Application No.: 09/892,662
Amdt. dated February 22, 2005
Reply to Office Action dated August 19, 2004

AMENDMENTS TO THE DRAWINGS

Title: LIQUID CRYSTAL DISPLAY DEVICE AND DRIVING METHOD
THEREOF

FIG. 1
CONVENTIONAL ART

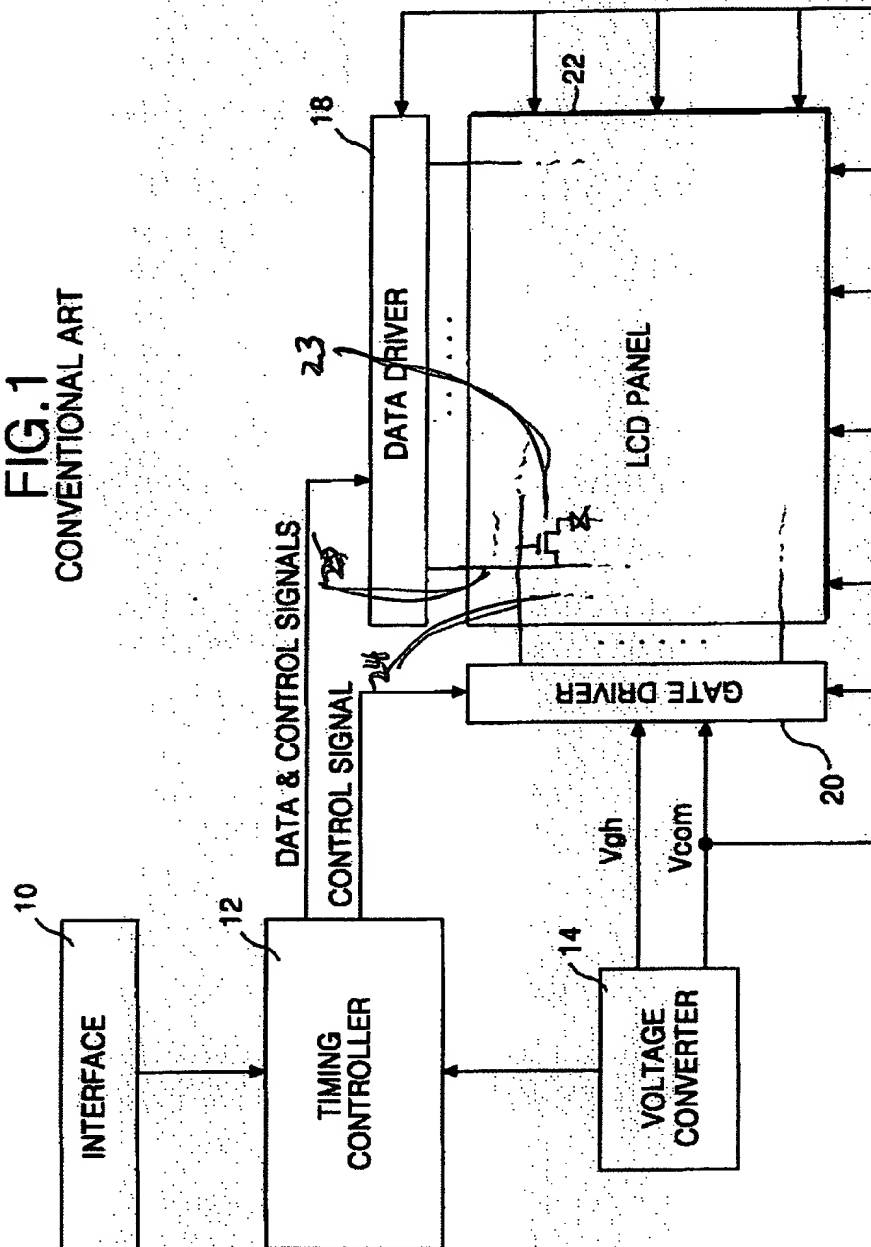
The attached sheets of drawings include changes to Figures 1, 3, 4, 6, 7, 9, and 10. These sheets, which include Figures 1, 3, and 4-10, replace the original sheets including Figures 1, 3, and 4-10. The following changes have been made to Figures 1, 3, 4, 6, 7, 9, and 10: previously omitted thin film transistor 23, scan line 24, and data line 25 are now shown in Figures 1, 3, 4, 6, 7, 9, and 10. It is respectfully submitted that no new matter has been entered.
